Amendments to the Drawings:

Attorney Docket No.: SNDK.006USS

Application No.: 09/129,675

REMARKS

FIG._7

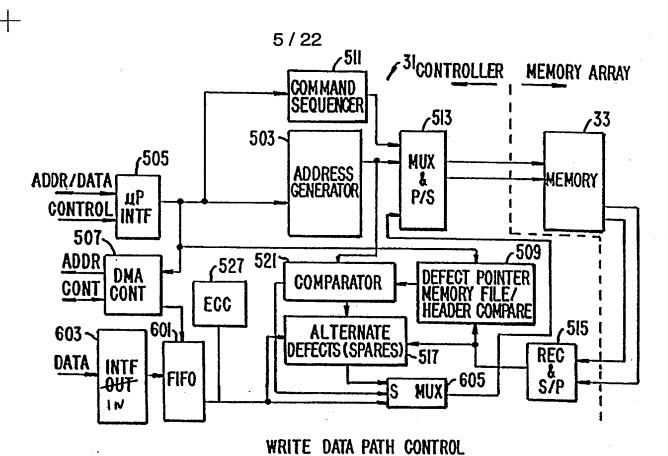
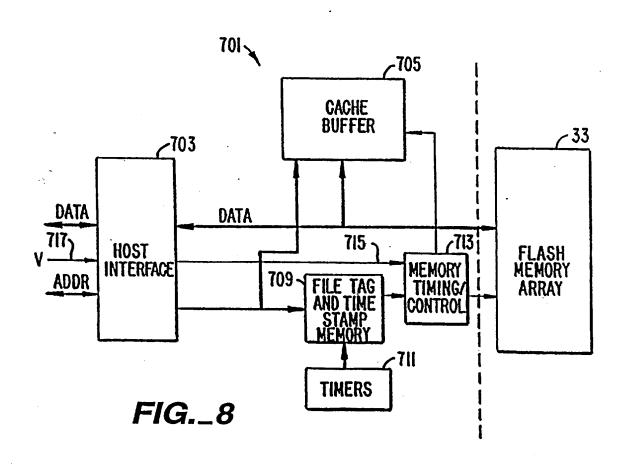
In Figure 7, block 603 is relabeled as --INTF IN--;

FIG._13

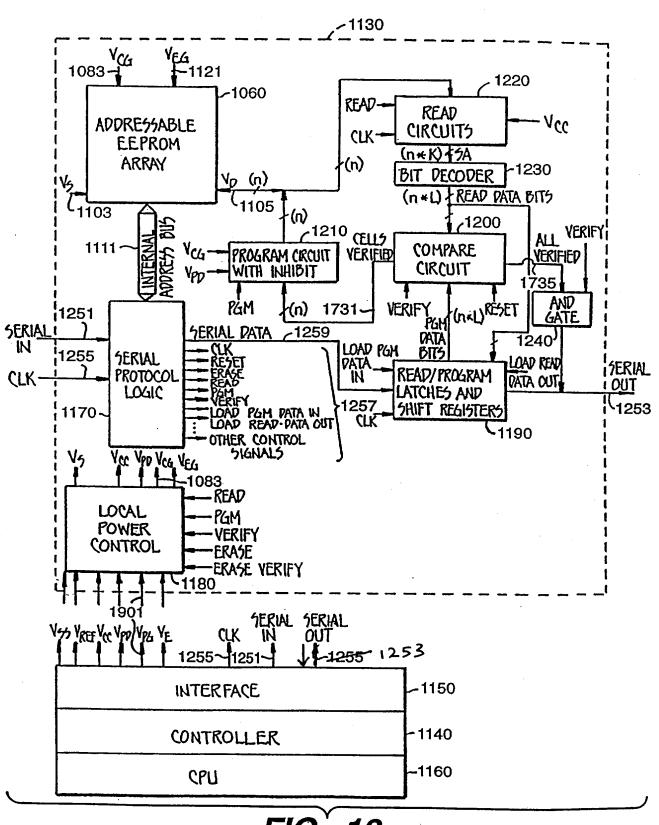
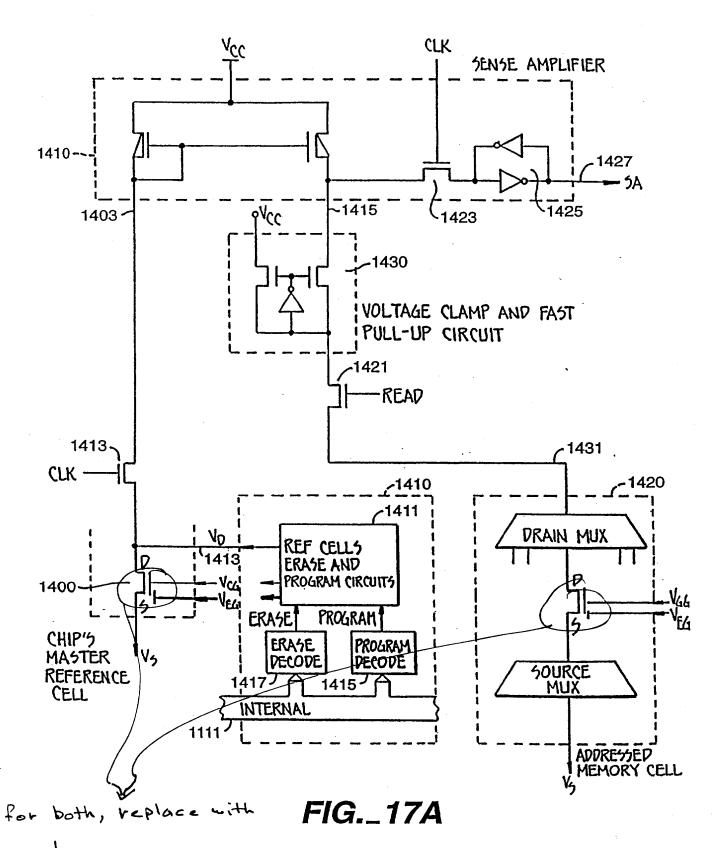
In Figure 13, the signal line "Serial Out" is relabeled as --1253-- and is now pointing toward block 1150;

FIG._17B

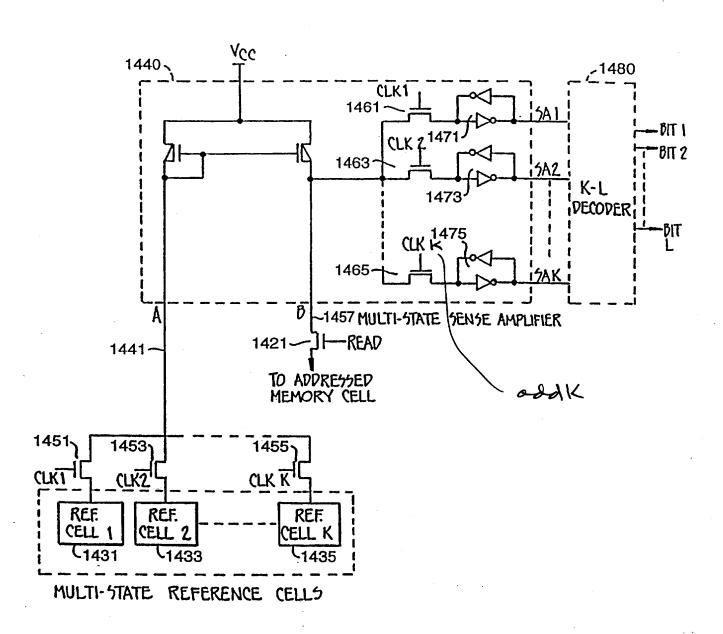
In Figure 17B, the control gate of 1465 has been relabeled --CLK K--;

FIG._21B

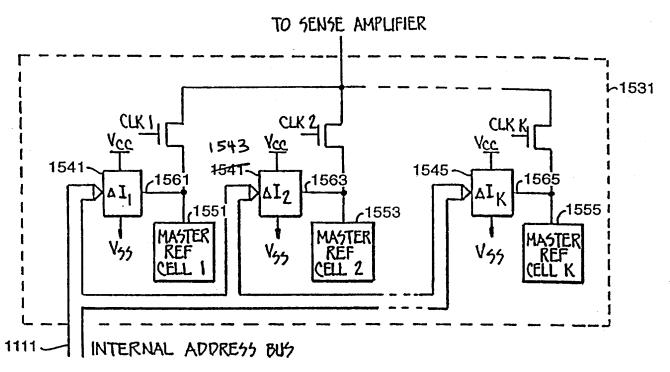
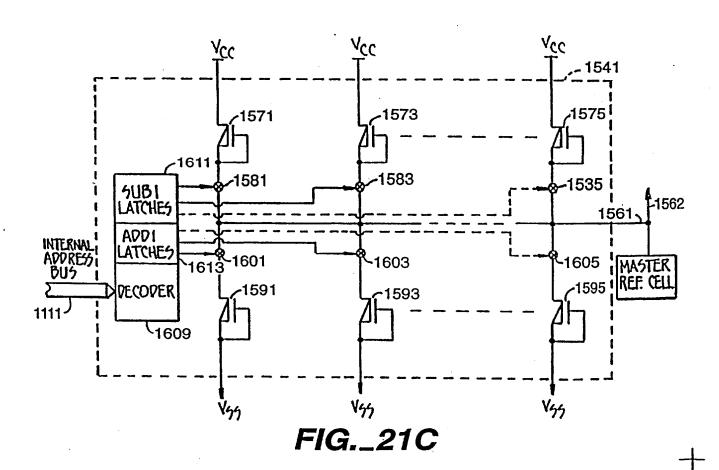
In Figure 21B, the block for ΔI_2 is relabeled as --1453--; and

FIG._22

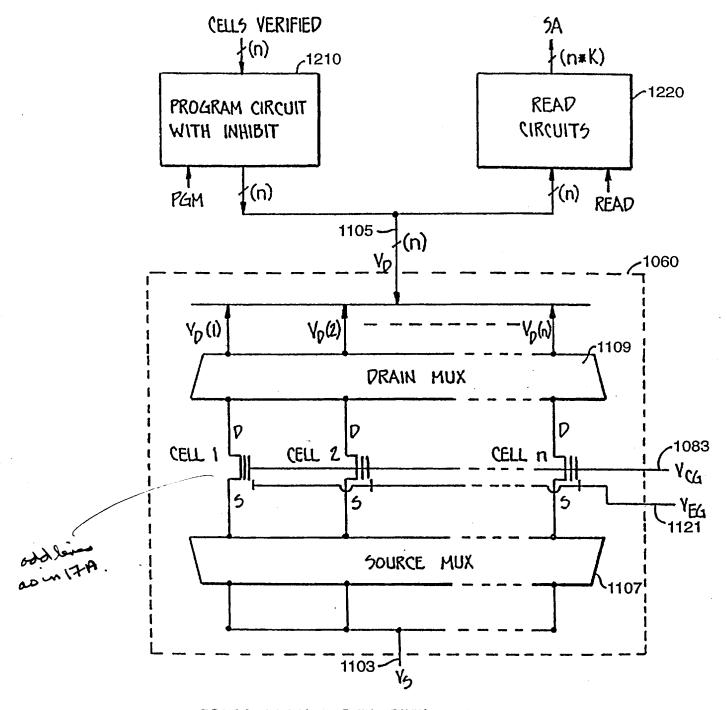
In Figure 22, the memory cells 1 to n have had floating gates added.
